WINDERMERE FILING NO. 2

EROSION CONTROL AND STORMWATER QUALITY PLAN

EPC STORMWATER REVIEW COMMENTS ARE SHOWN IN ORANGE BOXES WITH BLACK TEXT

PCD-ENGINEERING REVIEW COMMENTS IN BLUE BOXES WITH BLUE TEXT

NOTES

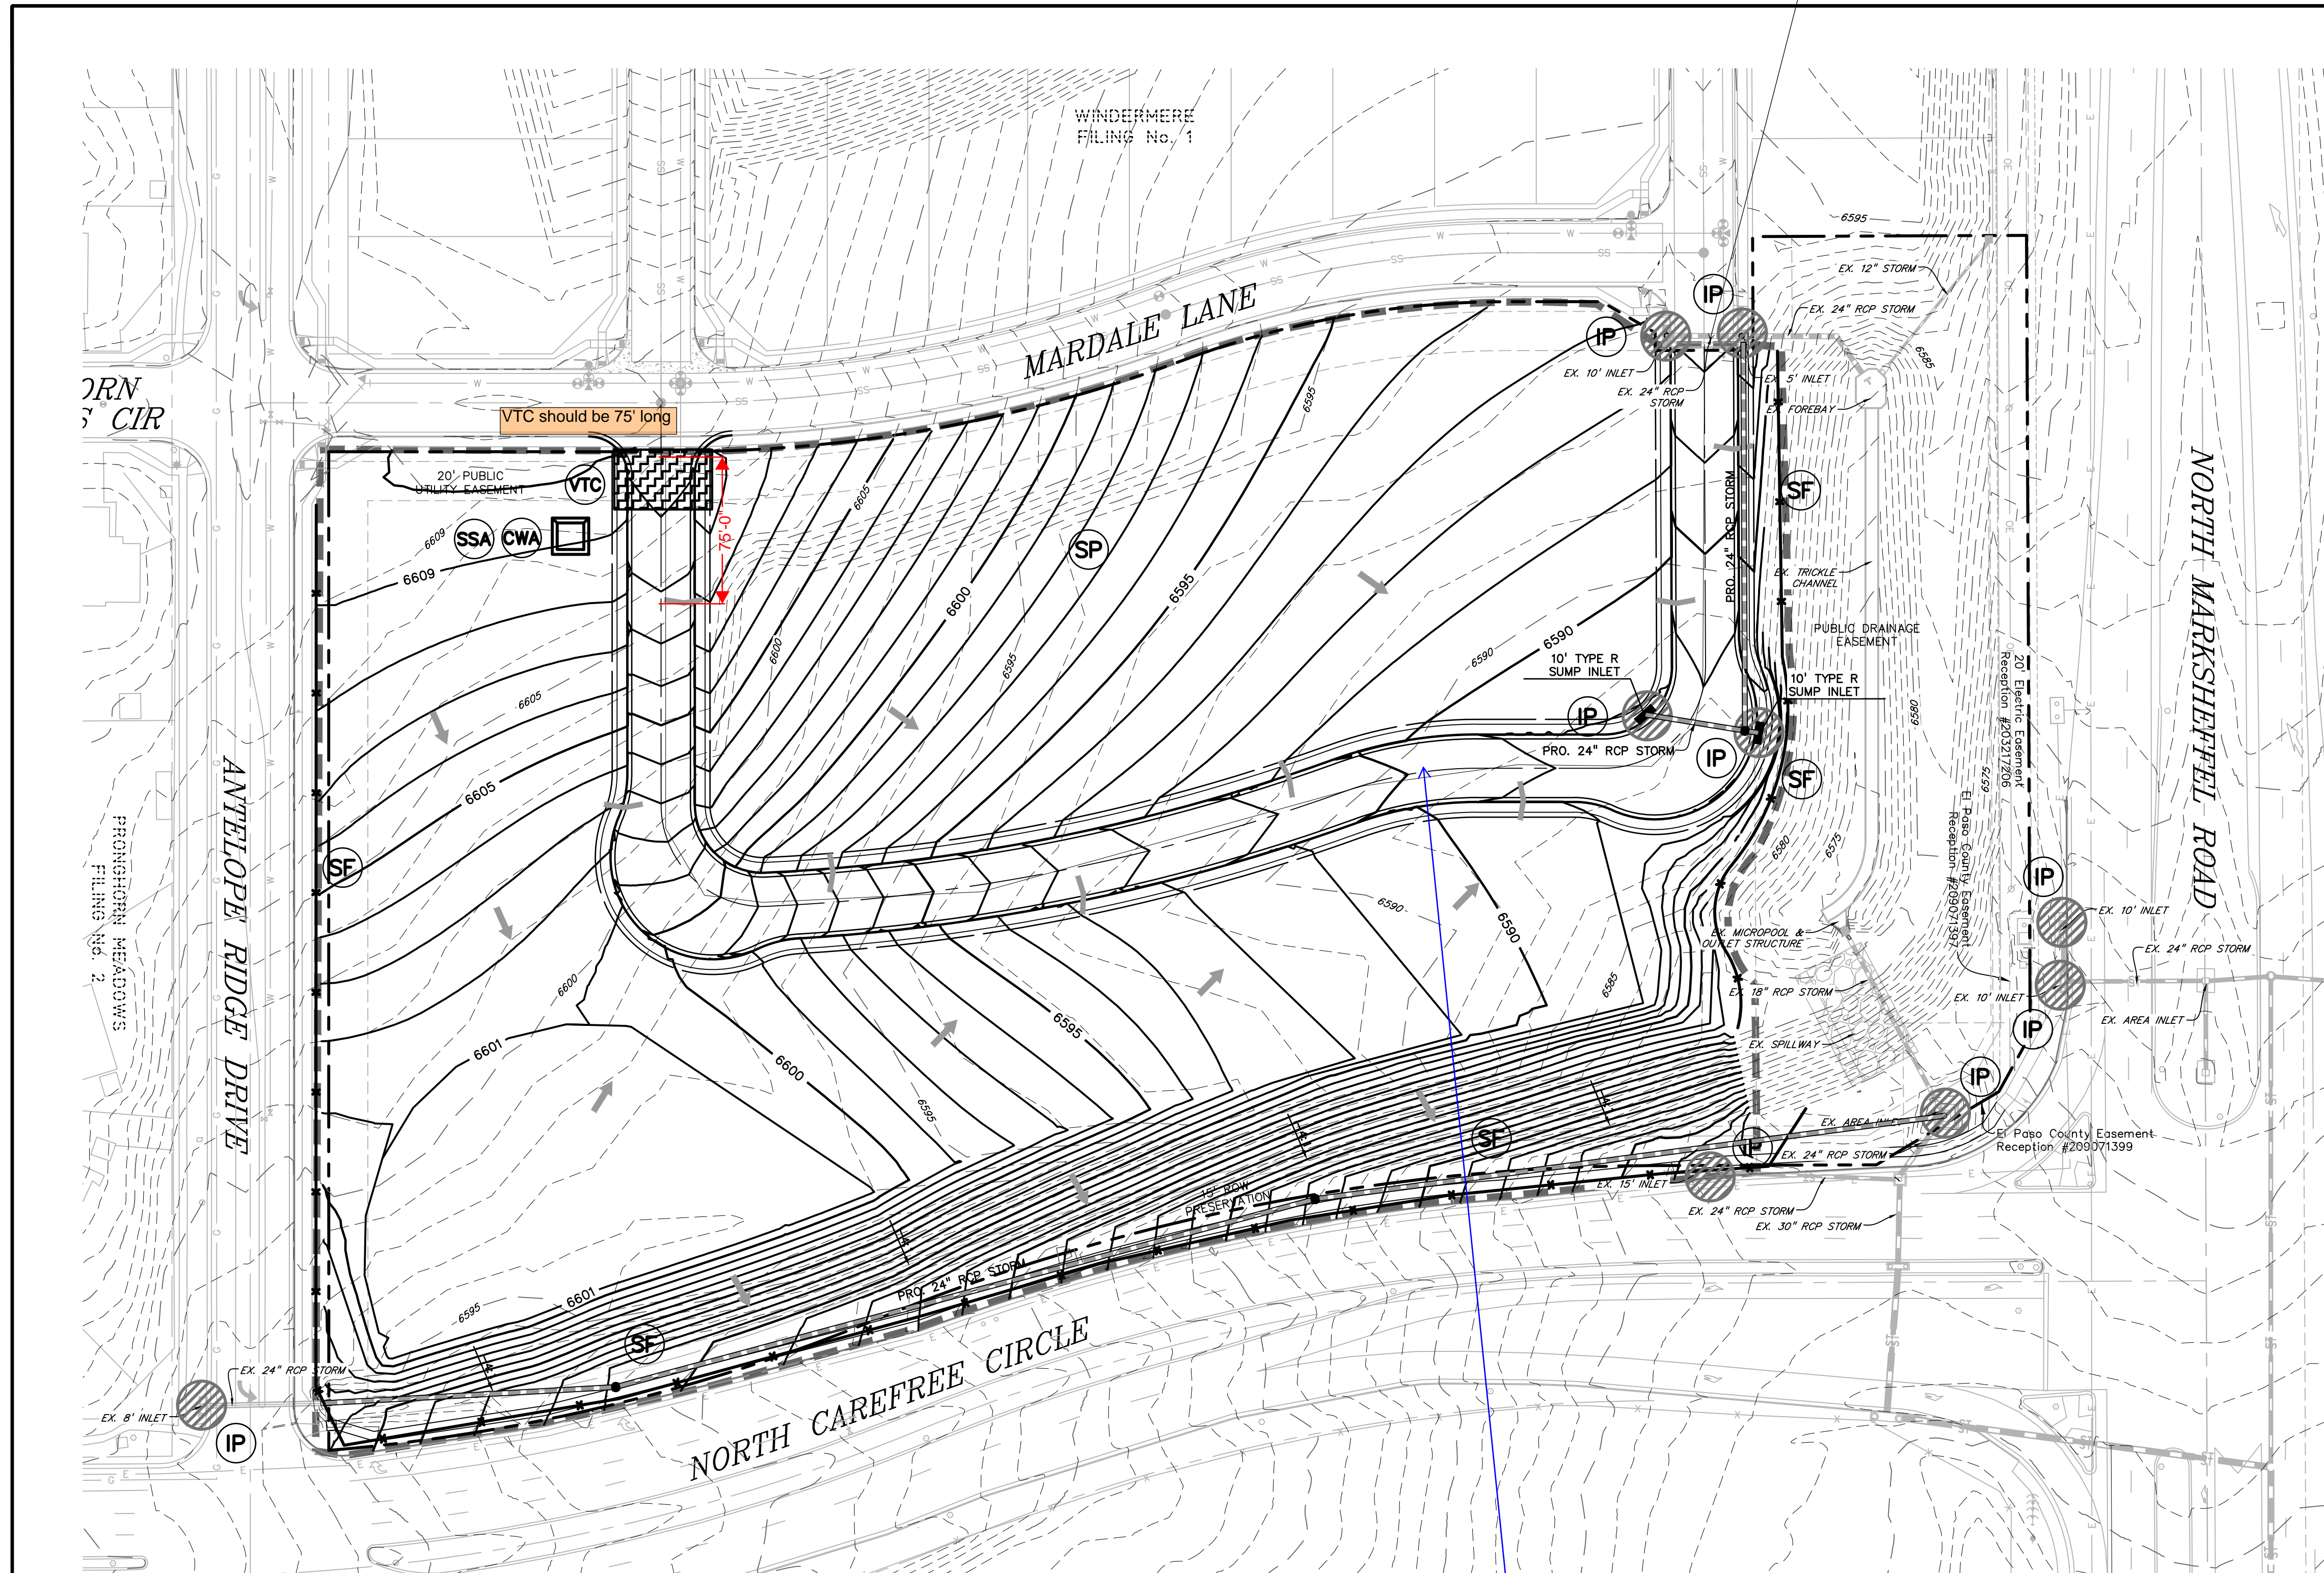
is this needed yet?

**INITIAL/INTERIM
EROSION CONTROL
PLAN**

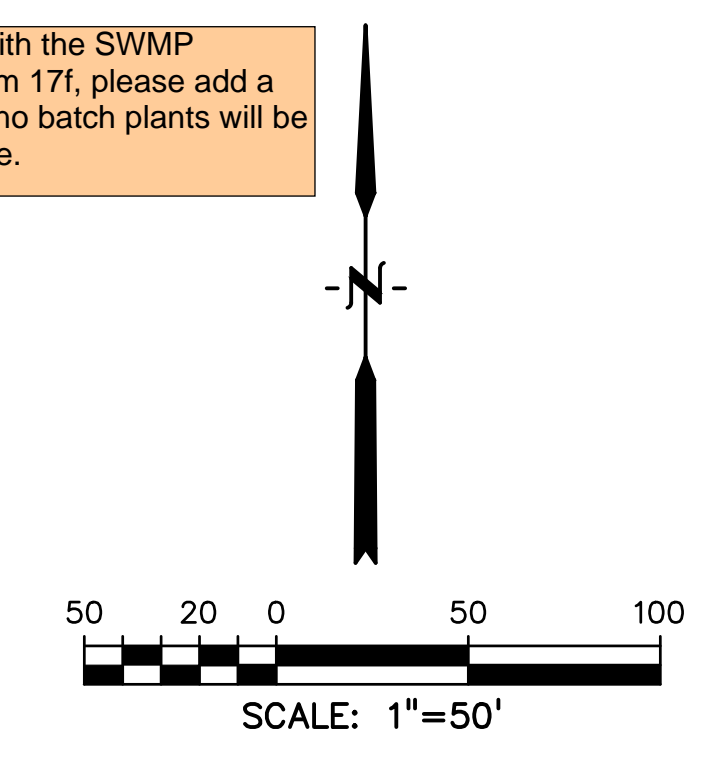
Item W. Provide construction fencing, barricades, and/or signage at access points not to be used for construction.

Proposed roads and storm drain shouldn't be shown for early grading initial BMPs

Item p. Show all areas of cut/fill

To comply with the SWMP Checklist Item 17f, please add a note stating no batch plants will be utilized onsite.

please separate initial and interim BMPs onto two separate sheets
